Royal Farms - Detail Site Plan

DETAILED SITE PLAN ROYAL FARMS

**STAFF REPORT
August 14, 2020**

ROYAL FARMS - GREENBELT
DETAILED SITE PLAN - DSP #19045

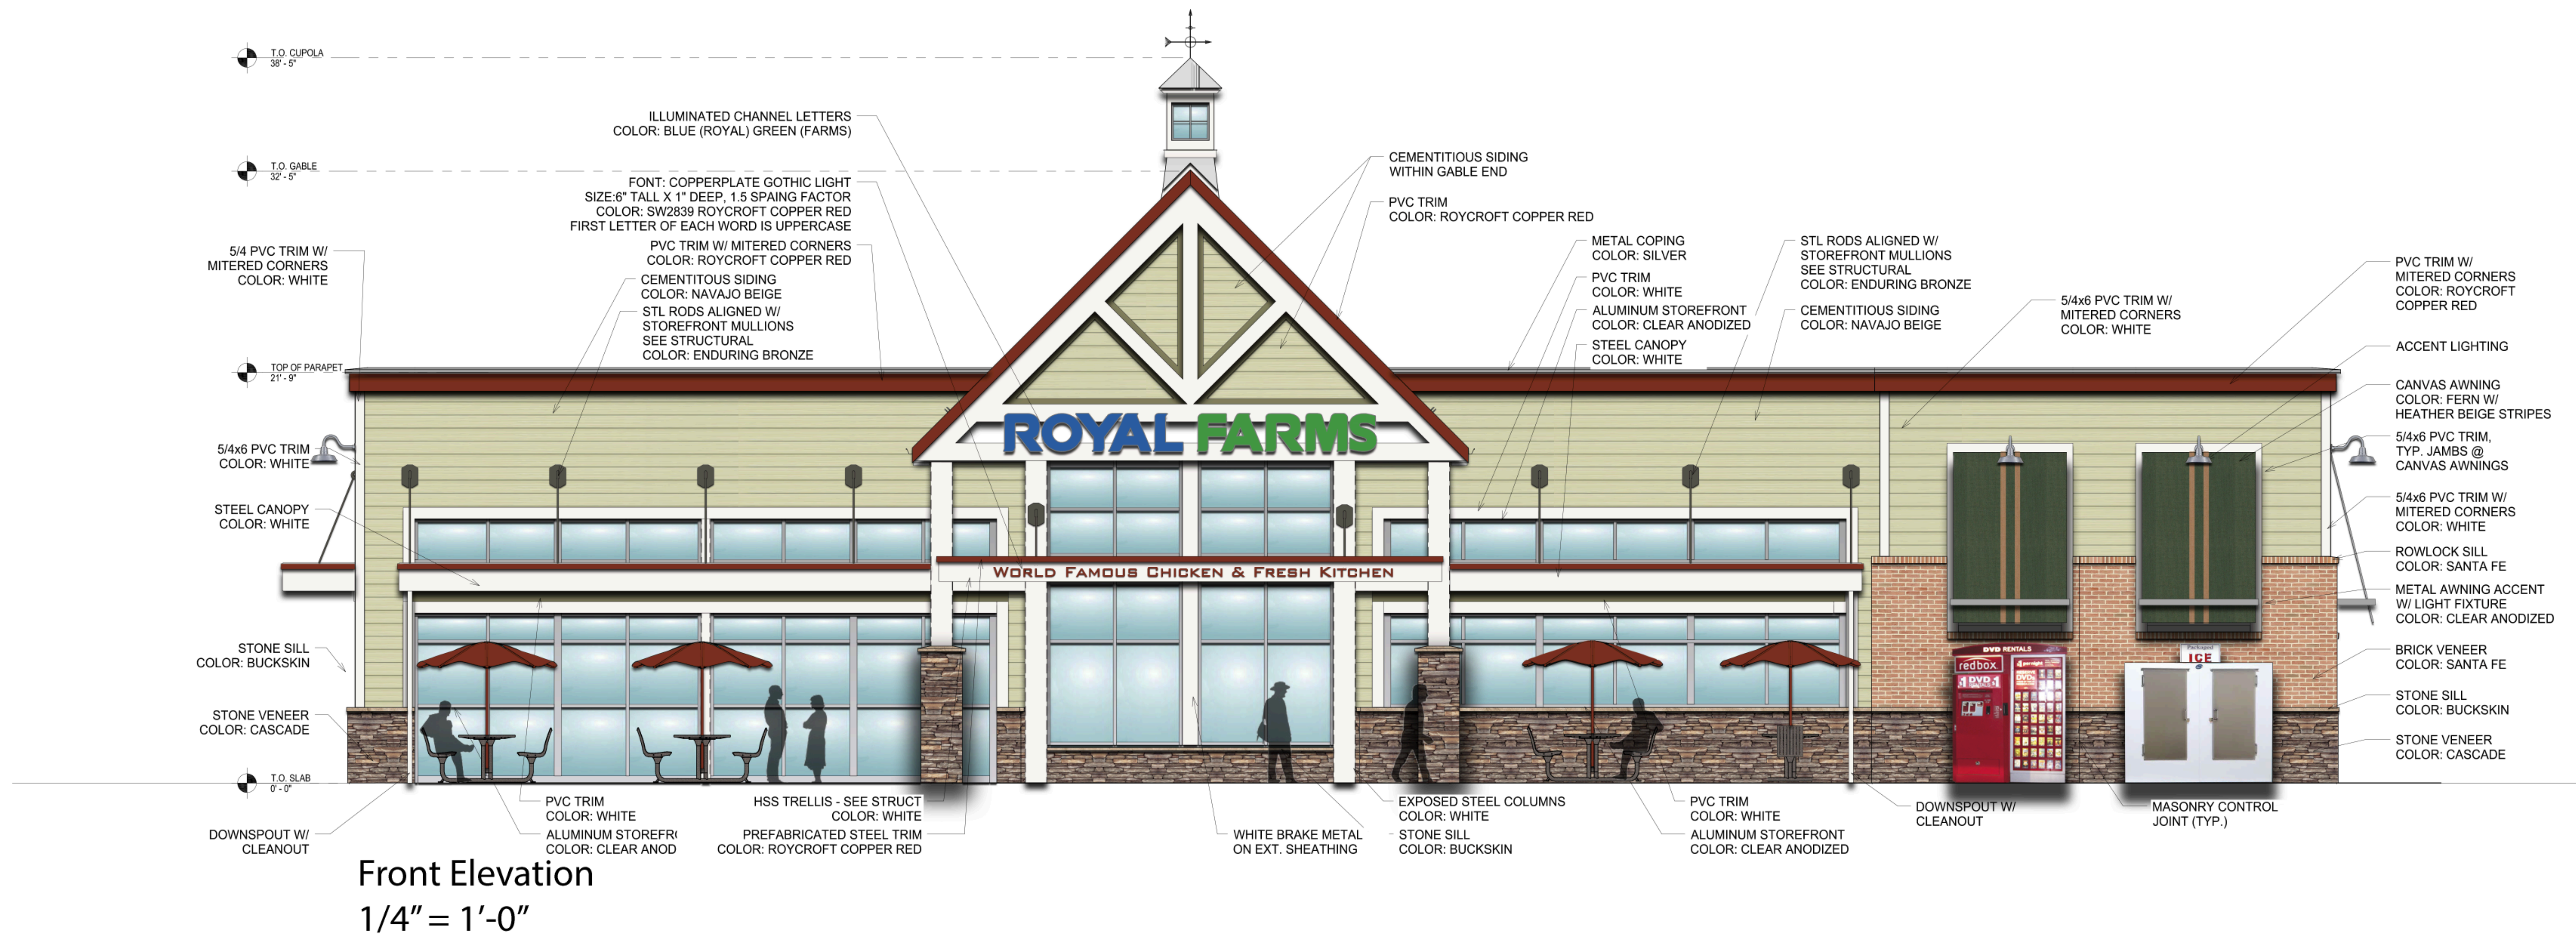
The revised proposed signage includes both freestanding signage and building mounted signage. Three (3) freestanding signs are proposed. The first is a Royal Farms monument sign that includes the gas prices on Greenbelt Road. This sign is proposed to be 8 feet tall and 15'-6" wide. The second sign is for the proposed second commercial building to be placed on Capitol Drive. This sign is proposed to be 8' tall and 5'-2" wide. The third freestanding sign is a directional sign proposed to be 4' tall and 1'-5 1/2" wide.

The revised sign plan also includes building mounted signage. On the Royal Farms food and beverage store the plan proposes one (1) wall mounted sign that reads "Royal Farms." This sign is proposed to be illuminated with LED lights. Also on the food and beverage store is a proposed "World Famous Chicken & Fresh Kitchen" sign. On the gas station canopy the plan proposes two (2) mounted signs, both that read "Royal Farms." On the proposed second commercial building one (1) mounted sign is proposed.
